Subject: N192219510 - Customer Satisfaction Program  
Rear Brake Pipe Protective Sleeve

Models: 2019 Chevrolet Silverado 1500  
2019 GMC Sierra 1500

## N192219510 Rear Brake Pipe Protective Sleeve

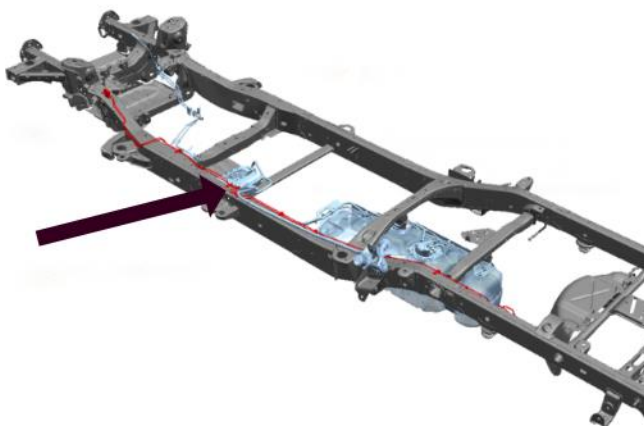
<b>Condition</b>	Certain 2019 model year Chevrolet Silverado 1500 and GMC Sierra 1500 vehicles, may have a condition in which the incorrect brake pipe protective sleeves were installed. This may cause minor surface damage to the brake pipe protective coating.
<b>Correction</b>	Dealers are to remove the existing protective sleeve and install the twist wrap protective sleeve.

4. Locate the two corrugated plastic sleeves on the rear brake pipes, remove and discard the sleeves.

5. Install the two new fabric protective sleeves on the rear brake pipes in the same position as the original corrugated plastic sleeves.
6. Reinstall the evaporative emission canister solenoid. Tighten 22Nm (16lb ft).
7. Lower the vehicle.

5022566

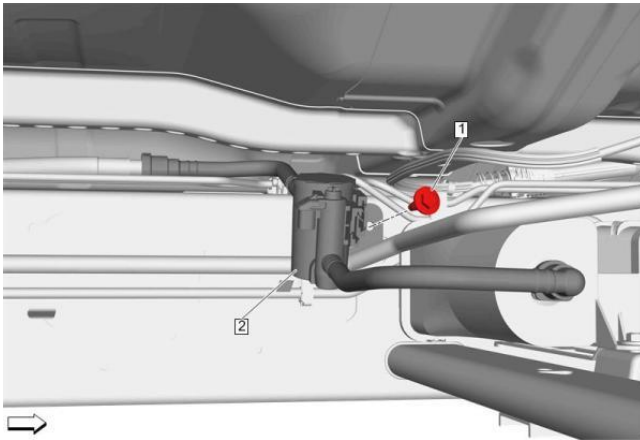
3. Remove the evaporative emission canister solenoid mounting bolt (1). Disconnect the solenoid electrical connector and hose fitting at the evaporative emission canister. Allow the solenoid to drop enough to allow access to the work area.
